## ADDENDUM NO. 1

**RE: NC School of Science and Mathematics (NCSSM)  
Campus-Wide HVAC Upgrades  
SCO ID #: 24-28565-01A; Code: 42219; Item: 306**

**DATE:** September 19, 2025

**FROM:** McKim & Creed

11 HOT WATER COIL PIPING

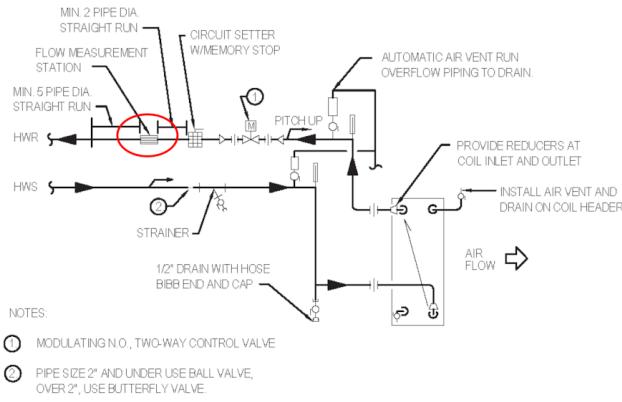
- Drawing M700 Detail 11 – Hot water Coil Piping shows a “Circuit Setter” and a “Flow Measurement Station”. Please provide a manufacturer / model number for the “Flow Measurement Station” and the “Circuit Setter”. (Note: specification 23-31-16 2.5 describes automatic flow control valves, but not circuit setters). If required, please add a shutoff valve on the heating water return piping

- **RESPONSE:** Detail 11 has been updated on the drawings. Flow measurement station was removed, and isolation valve was added. Note 1 was changed to “2-way control valve”. Specifications have also been updated to include information on circuit setters.
- Drawing M700 Detail 9 – Chilled water Coil Piping shows a “Flow Measurement Station” and a “Pressure Independent Control Valve”. Please provide a manufacturer / model number for the “Flow Measurement Station”. If required, please add a shutoff valve on the chilled water return piping.

DATE	09/19/2025
MIC PROJ #	06376-0012
SCO ID #	24-28565-01A
DESIGNED	
CHECKED	
PROJ. MGR	
CONSTRUCTION DOCUMENTS	
MECHANICAL NEW WORK PLAN - HUNT GROUND FLOOR	
<b>M-100</b>

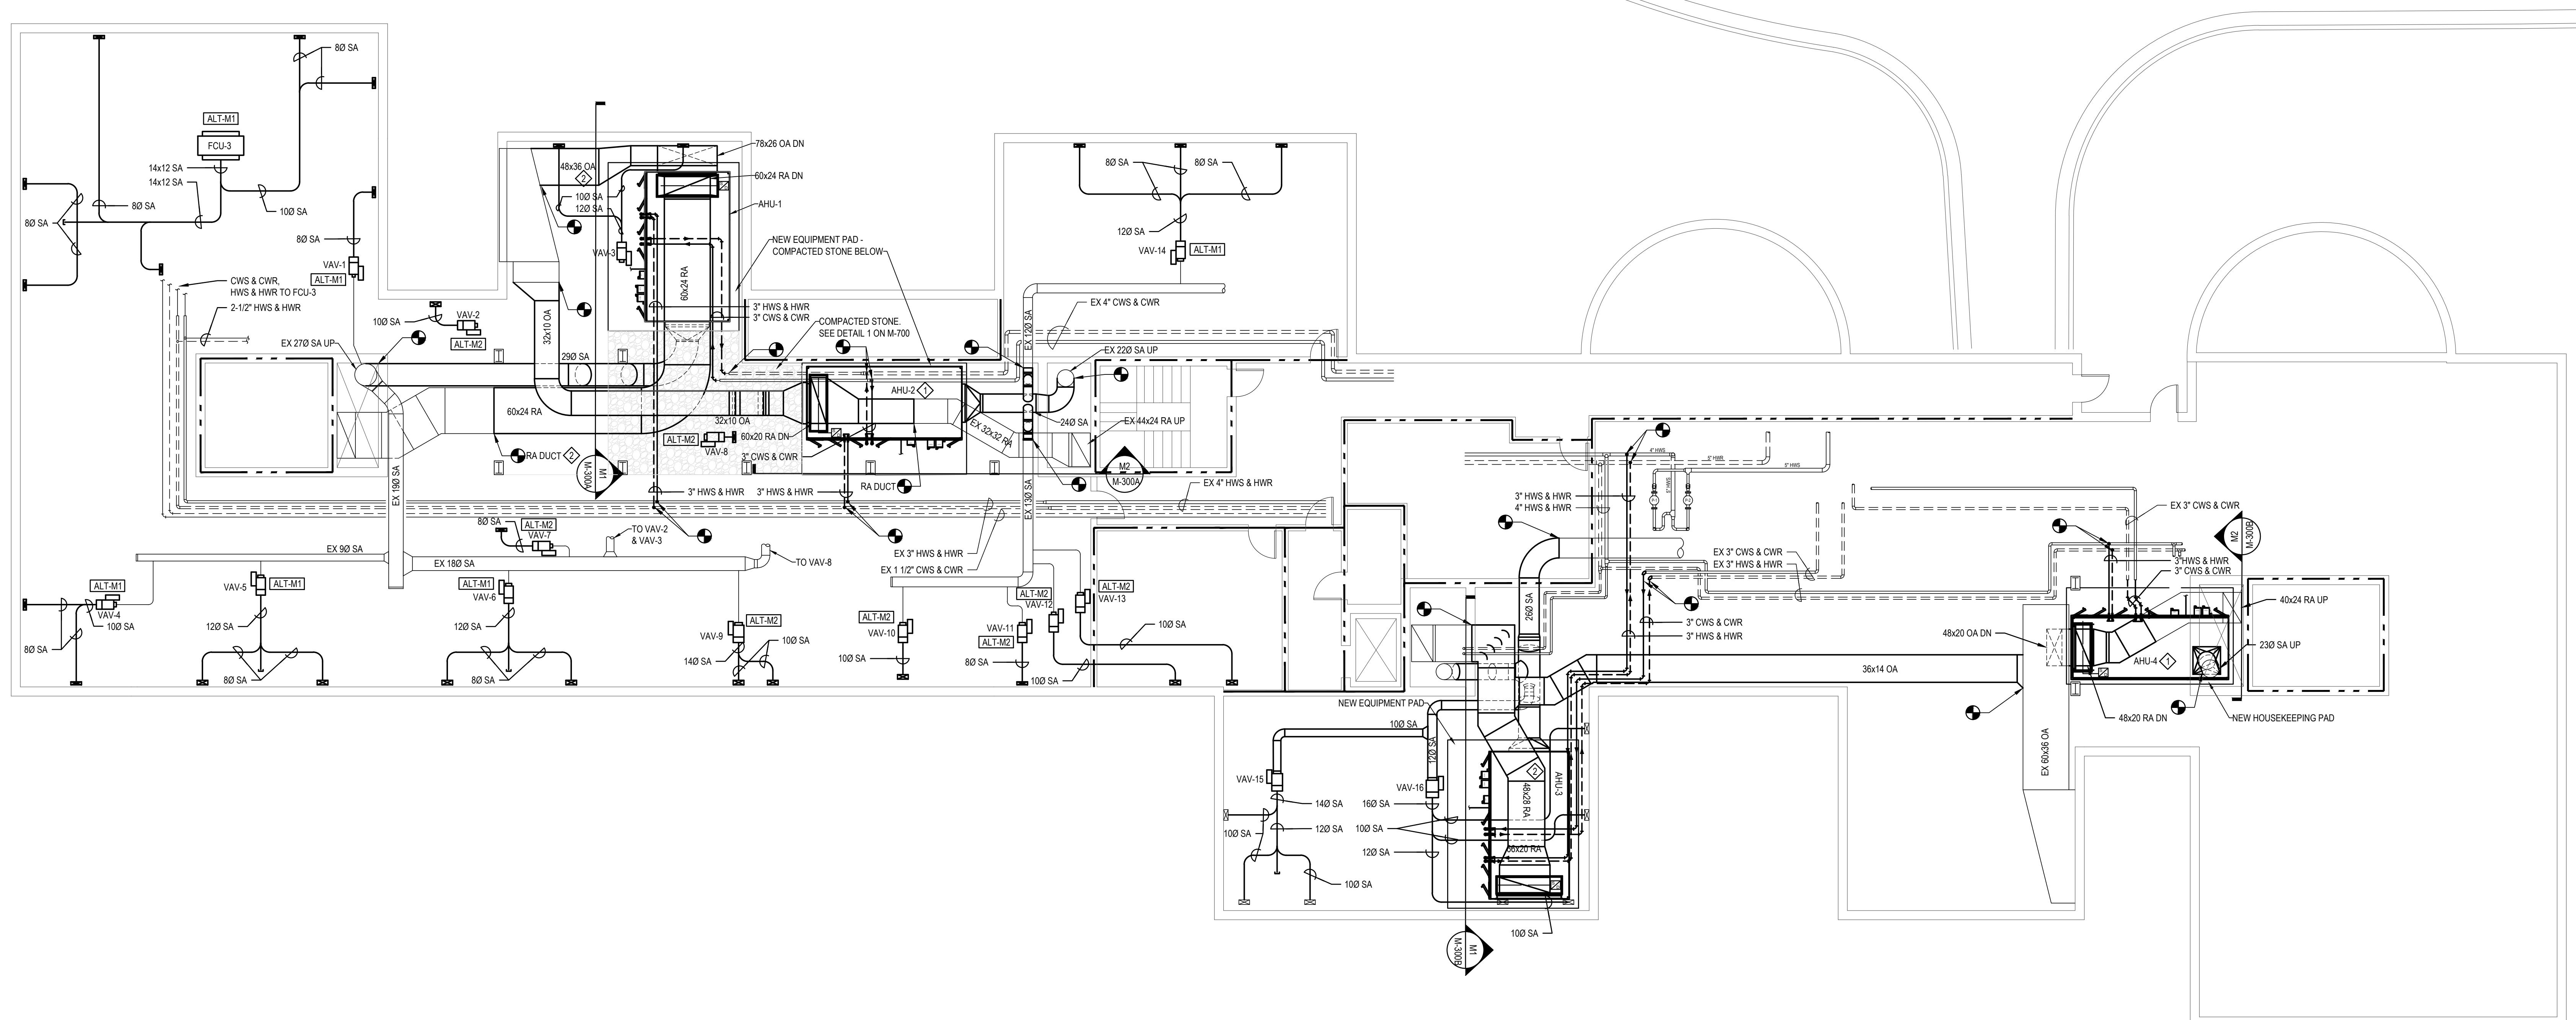
- a. BCS-1 – Revised electrical lead design professional information.
- b. MD-100, M-100, M-100A, M-100B, M-101 – Revised Bid Alternate descriptions to indicate re-using terminal unit controllers and wireless thermostats.

- c. M-100 – Added more specific notes about fire-protection work.
- d. M-100A, M-300A, M-300B – Added hatching and revised keynote for new compacted stone to be added to mechanical room floor where new air handling units are going to be installed. Added hatching for existing gravel in section views as well.

1. INSTALLATION OF NEW AIR HANDLING UNIT AND ASSOCIATED DUCTWORK IS NOT EXPECTED TO AFFECT EXISTING FIRE PROTECTION SPRINKLER COVERAGE. CONTRACTOR SHALL FIELD-VERIFY AND ENSURE COMPLIANCE WITH NFPA 13 REQUIREMENTS UPON COMPLETION OF NEW WORK.
2. FIRE PROTECTION SPRINKLER COVERAGE IS REQUIRED UNDER ALL OBSTRUCTIONS OVER 48" PER NFPA 13.8.5.3.1. CONTRACTOR TO ADD SPRINKLER HEADS, AS NECESSARY, UNDER NEW DUCTWORK THAT EXCEEDS 48" INCLUDING INSULATION.

DATE	09/19/2025
MIC PROJ #	06376-0012
SCO ID #	24-28565-01A
DESIGNED	
CHECKED	
PROJ. MGR.	
CONSTRUCTION DOCUMENTS	
MECHANICAL NEW WORK PLAN - HUNT FIRST FLOOR	
<b>M-101</b>

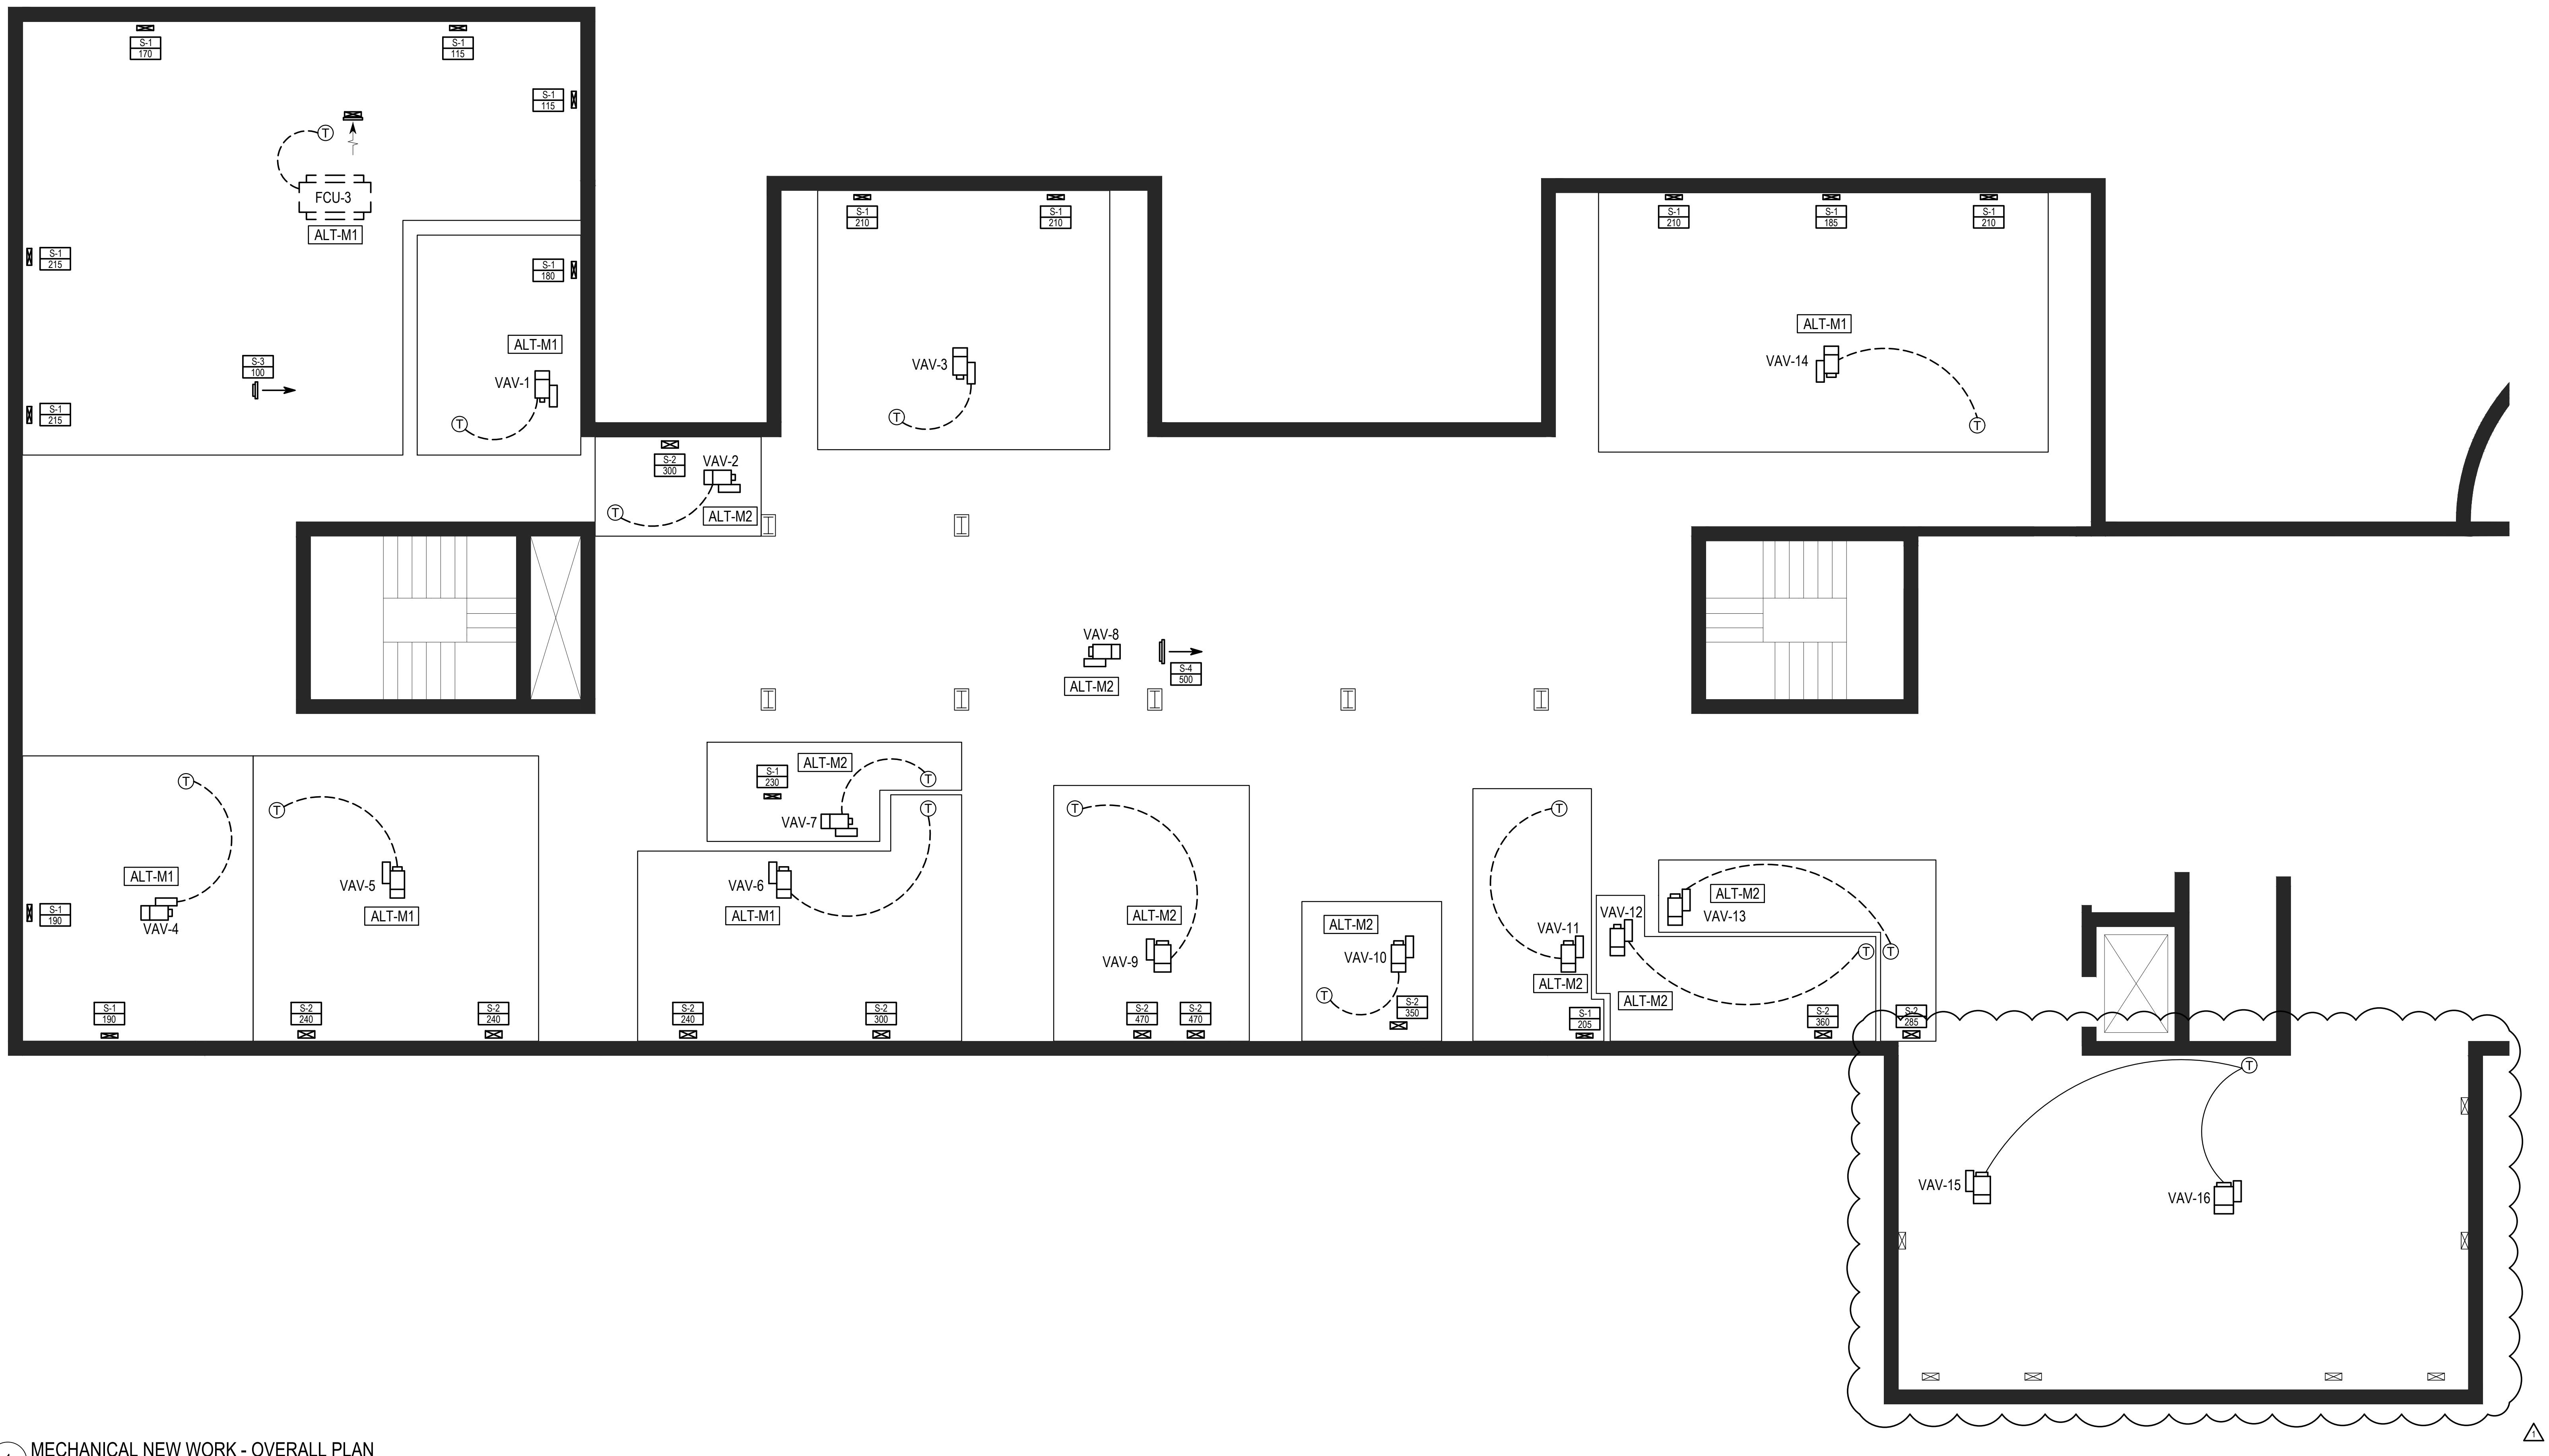
- e. M-101 – Expanded drawing to include VAV-15 & VAV-16. Revised general note #3 and added note #1 to diffuser schedule.
- f. M-700 – Replaced Detail #1 with a more comprehensive equipment pad detail. Revised details #9 and #11 to remove flow measurement stations and add isolation valves.

- LOCATION OF TERMINAL UNITS, THERMOSTATS, AND AIR DISTRIBUTION DEVICES IS SHOWN IN APPROXIMATED LOCATIONS AND SUBJECT TO FURTHER DEFINITION.
- EXISTING TERMINAL UNIT CONTROLLERS AND WIRELESS THERMOSTATS ARE TO REMAIN. CONTRACTOR SHALL REMOVE EXISTING CONTROLLERS AND INSTALL THEM ON TO NEW TERMINAL UNITS.
